Product Change Notification / GBNG-16LFXC744

CCB 3430.005 Final Notice: Qualification of MTAI as an additional assembly site for selected PIC16F1919x, PIC16LF1919x, PIC18F6xxx and PIC18LF6xxx device families available in 64L QFN (9x9x0.9mm) package.

**CCB 3430.005**  
**Pre and Post Change Summary**  
**PCN #: GBNG-16LFXC744**

# LEAD FRAME COMPARISON

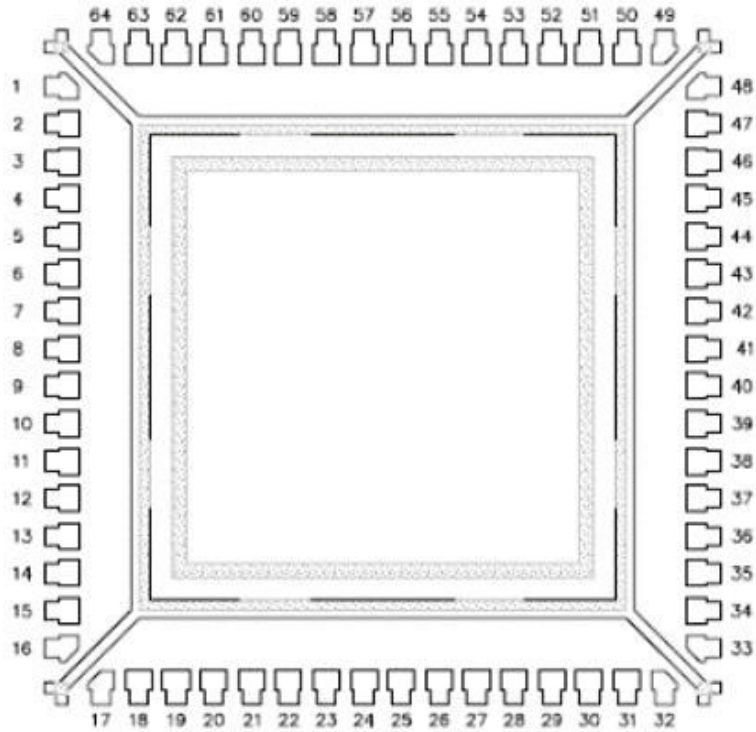
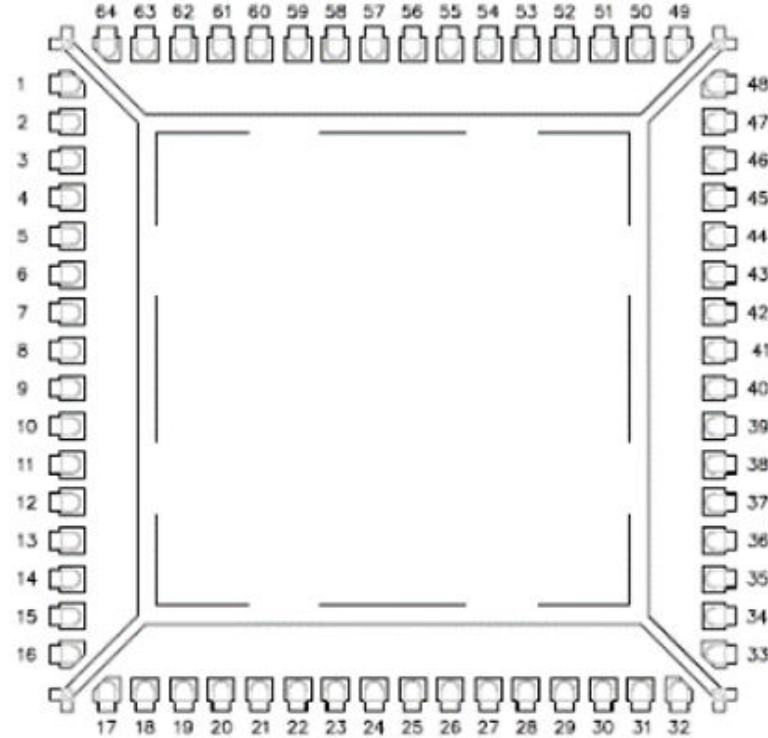
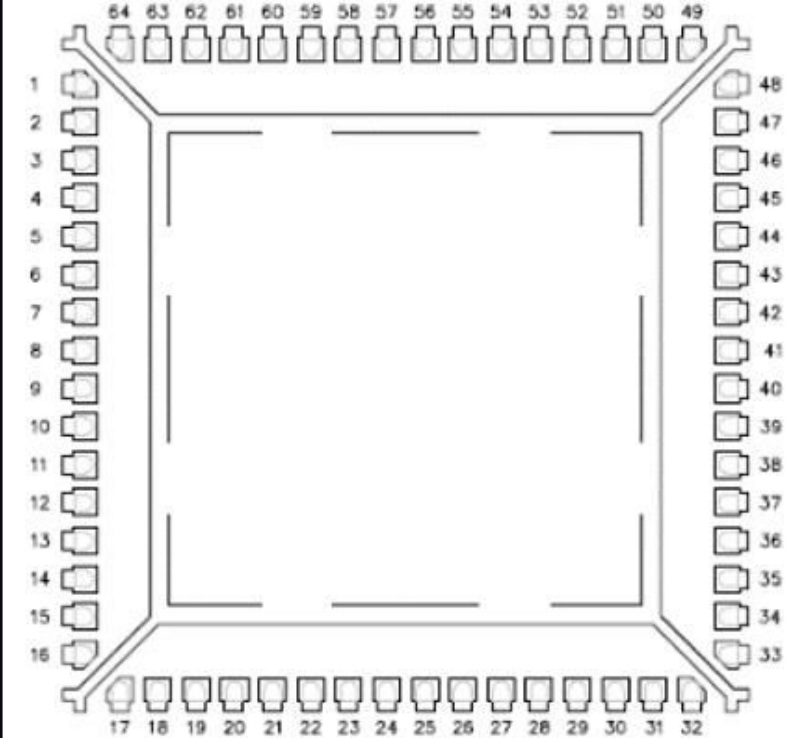
Pre Change		Post Change		
<b>Assembly Site</b>	UTAC Thai Limited (UTL-1) LTD. (NSEB)		UTAC Thai Limited (UTL-1) LTD. (NSEB)		Microchip Technology Thailand (HQ) (MTAI)
<b>Wire material</b>	Au		Au		Au
<b>Die attach material</b>	8600		8600		3280
<b>Molding compound material</b>	G700LTD		G700LTD		G700LTD
<b>Lead frame material</b>	EFTEC-64T		EFTEC-64T		C194
<b>Lead frame DAP surface prep</b>	Ag	Bare Cu	Ag	Bare Cu	Bare Cu
<b>Lead frame design</b>	See attached pre and post change comparison

Lead frame DAP surface prep

Ag

Lead frame DAP surface prep

Bare Cu

Lead frame DAP surface prep

Bare Cu
